# HISTORIC AND DESIGN REVIEW COMMISSION

August 15, 2018

**HDRC CASE NO:** 2018-355  
**ADDRESS:** 1103 N OLIVE ST  
**LEGAL DESCRIPTION:** NCB 514 BLK 18 LOT 20  
**ZONING:** R-6 H  
**CITY COUNCIL DIST.:** 2  
**DISTRICT:** Dignowity Hill Historic District  
**APPLICANT:** Kris Sumantri  
**OWNER:** North Olive 1103 Trust  
**TYPE OF WORK:** Exterior modifications, construction of a rear deck, installation of front and side yard fencing  
**APPLICATION RECEIVED:** July 13, 2018  
**60-DAY REVIEW:** September 11, 2018

① PARTIAL EAST EXTERIOR  
3/16" = 1'-0"

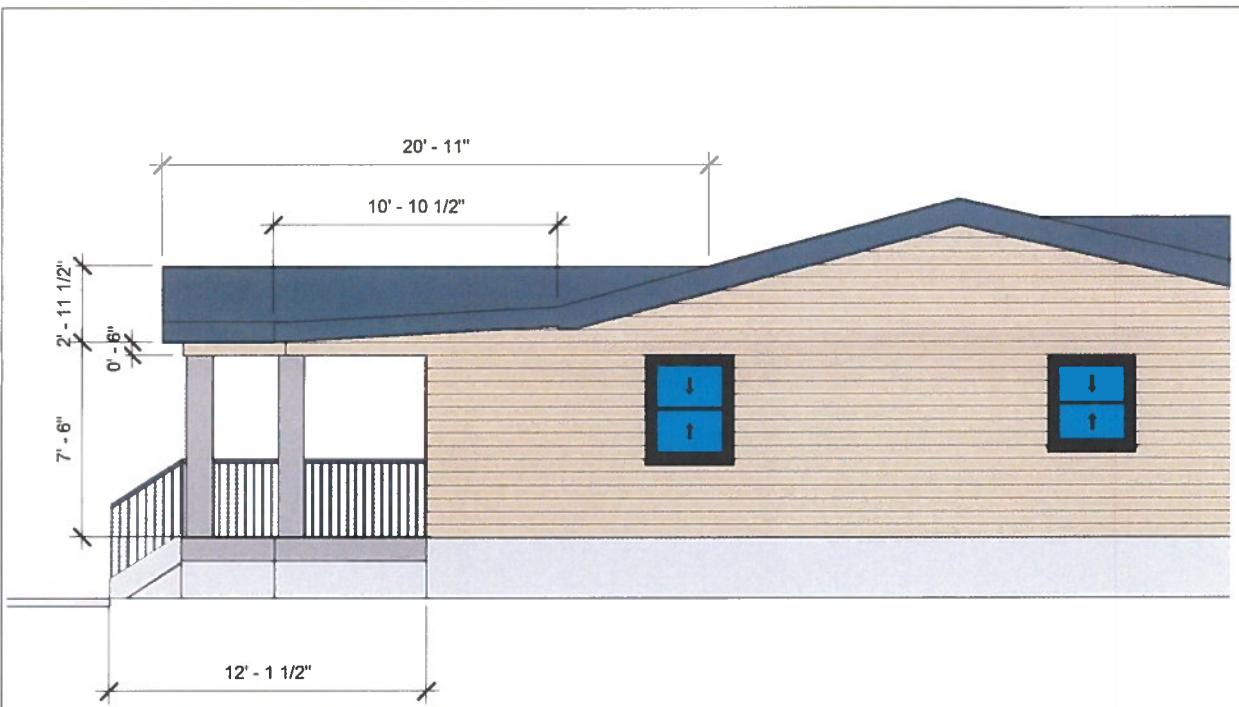
- b. **FENESTRATION MODIFICATIONS** – The applicant has proposed to modify the existing fenestration. Modifications include the removal of one front window, an addition of a horizontal rectangular window in the rear, and a new pair of French doors leading to a proposed rear deck where sliding doors are currently located. Staff does not find the removal of the front window appropriate and finds that any new window openings should feature traditional profiles, proportions, configurations, and insets. Staff finds the installation of French doors appropriate.

- d. **FRONT ADDITION** – The applicant has proposed to enclose an existing front porch to create a front addition. The current porch is a simple shed roof with simple column supports. The existing porch deck is constructed of wood. In the submitted drawings, the applicant has proposed to capture this footprint and create interior conditioned space. According to the Historic Design Guidelines, new additions or interior space should be located towards the rear of the property whenever possible. The enclosure of this porch area would also create a front setback that is greater than the neighboring historic structure, which would result in the addition being the dominant feature on the streetscape. Staff finds that modifications to the design and details of the current front porch may be appropriate, but finds that enclosing the porch to create a new front addition is inconsistent with the Guidelines.

- e. **NEW FRONT PORCH** – The applicant has proposed to construct a new front porch in front of the proposed addition as noted in finding d. The applicant has proposed a more traditional front gable porch with simple square columns. The footprint of the porch will extend towards the street by approximately 10 feet. The proposed columns are 10 inches in width. While staff finds the concept of front porch modifications generally appropriate as noted in finding d, the extension of the building footprint towards the street would significantly modify the front setback relationship with the neighboring historic structure and development pattern of historic structures in the vicinity as noted in finding d. Staff also finds that any proposed porch columns should not exceed 6 inches in width.

Item 1, Staff recommends approval of the fenestration modifications based on finding b with the following stipulations:

- i. That a window opening on the left side of the front façade be retained. The applicant is required to submit updated drawings to staff for review and approval.
- ii. That applicant proposes an alternative window size that is consistent with the Historic Design Guidelines in lieu of the proposed rectangular window on the north façade.
- iii. That the applicant complies with the requirements of the window replacement proposal approved by the HDRC on July 18, 2018, and submits any updated window product information to staff.

Items 3 and 4, Staff does not recommend approval of the front addition and new front porch based on findings d and e. Staff finds that the applicant should refrain from creating conditioned interior space on the front of the structure and should relocate any additions to the rear. Staff also finds that any front porch design modifications should be made within the footprint of the existing front porch to maintain a consistent street setback as noted in finding e.

② SOUTH EXTERIOR ELEVATION  
3/16" = 1'-0"

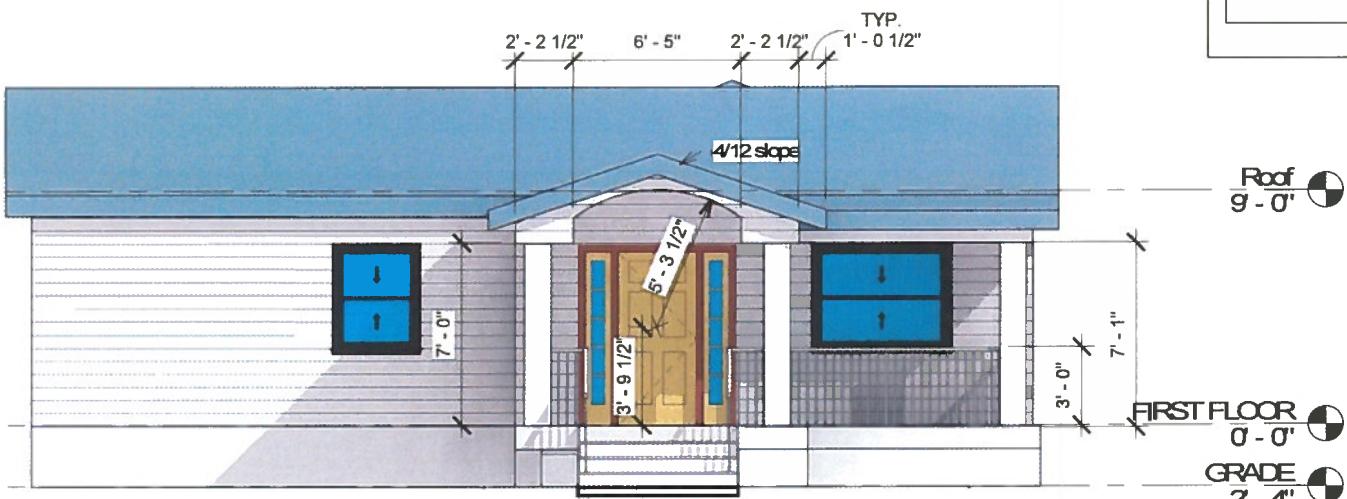
- c. **SIDING REPLACEMENT** – The applicant has proposed to remove the cement board siding and replace with new Hardie plank siding. Staff finds this to be appropriate with the stipulations listed in the recommendation.

Item 2, Staff recommends approval of siding replacement based on finding c with the stipulation that the reveal not exceed six inches and that the smooth side of the board be used.
